MONTGOMERY COUNTY HISTORIC PRESERVATION COMMISSION
STAFF REPORT

Address:	10301 Armory Avenue, Kensington	Meeting Date:	2/21/2024
Resource:	Primary Resource Kensington Historic District	Report Date:	2/14/2024
Applicant:	Alexis Gurganious McCarthy	Public Notice:	2/7/2024
Review:	HAWP	Tax Credit:	Partial
Permit Number:	1057271	Staff:	Chris Berger

PROPOSAL: New roof, new vent pipe and vents, new pad and HVAC installation

Figure 4. The applicant provided this diagram to show the location of the pad holding the heat pump and condensing unit in the rear yard.

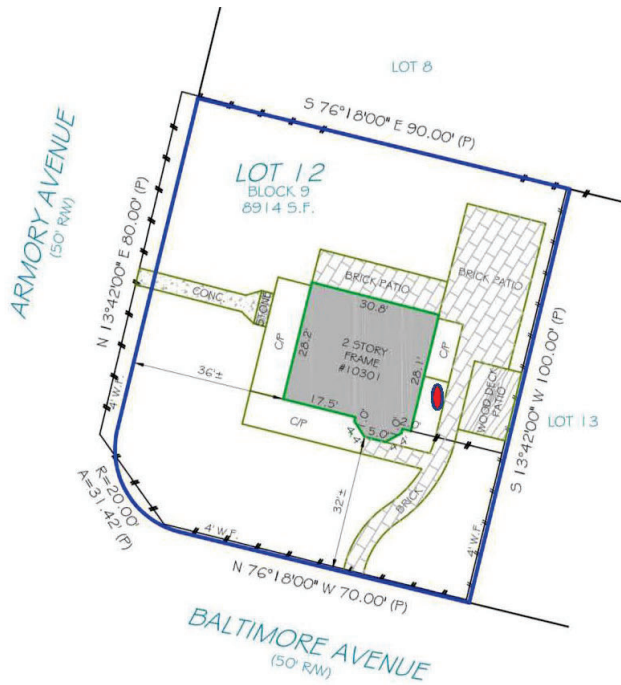
Staff finds the HVAC system installation meets the applicable regulations and recommends approval. All the alterations will be located in the rear yard and will be minimally visible from the right of way. The applicant has demonstrated a willingness to minimize the visual impact of the lines to be installed on the rear elevation by proposing to paint the plastic coverings that will go over the refrigerant lineset, drain hose, and power lines.

**Historic Area Work Permit
10301 Armory Ave Kensington, MD 20895
Work Item #3– New HVAC (cont.)**

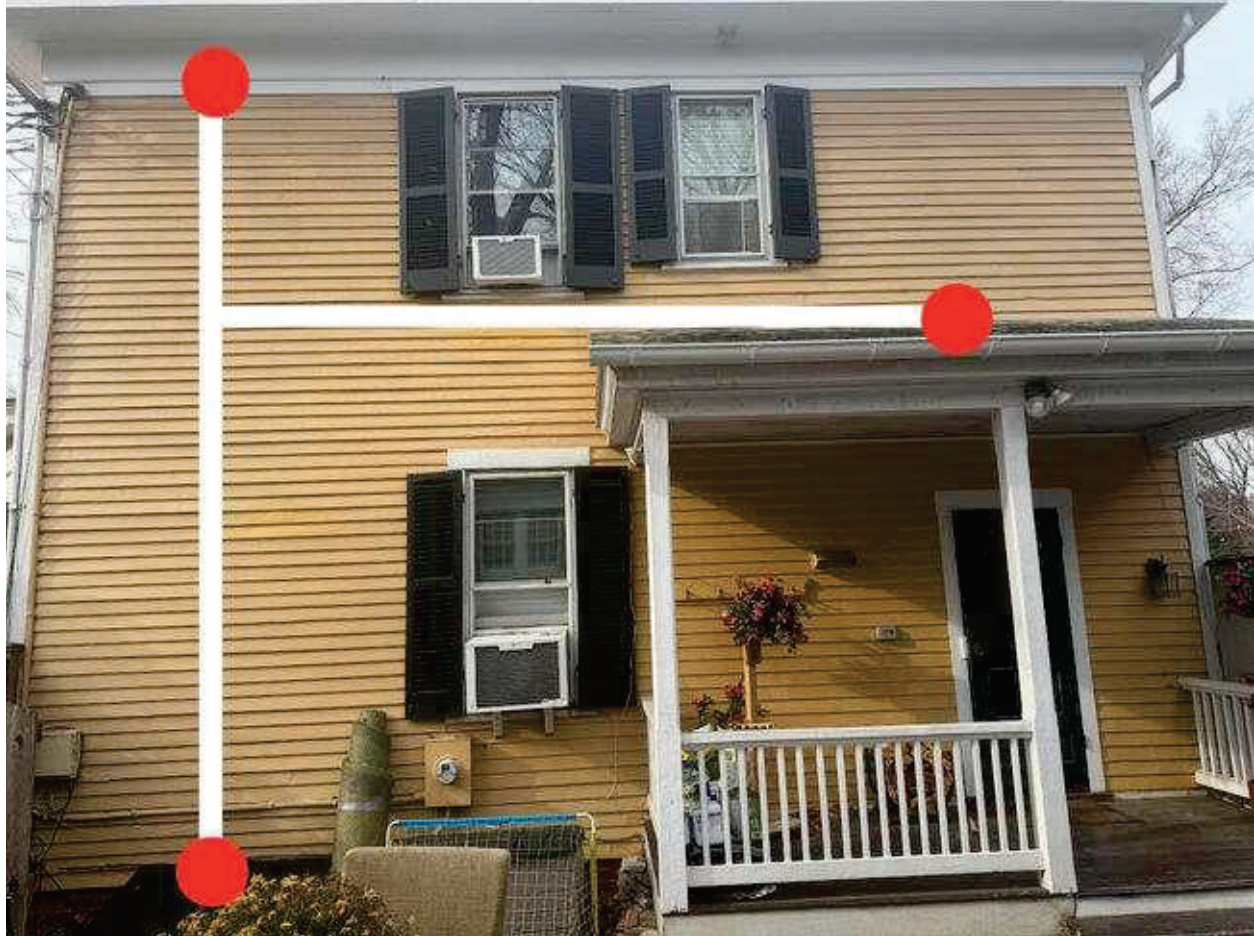
- For the New HVAC, under proposed work, you wrote on the project description that the heat pump units will be on a poly pad, but the photo and diagram says they will be on a 48-by-30 inch concrete pad. Please clarify the pad material.
- Please show the location of the proposed fan coil unit on the exterior wall and provide the unit's approximate dimensions. A specification sheet for the unit or representative photo would also be helpful.
- The proposed concrete pad size is described as 48 inches long on the diagram. Please double check that measurement and confirm there is enough space between the porch and cellar door to fit 48-inch long pad. (It may the stones and board in the photos provided that makes the area appear smaller than reality.) Also provide the distance of the pad from the nearby basement window well.

A poly HVAC pad is fine. I just wanted to know which material you planned to use. Thank you for confirming the area where the pad will be located is large enough.

- Thanks for flagging the pad material. I initially received two quotes -- one that would use concrete and one that would use a poly pad -- so I was open to either. However, in doing my own independent research, it sounds like the poly pad is preferred. Does choosing the poly pad impact approval?
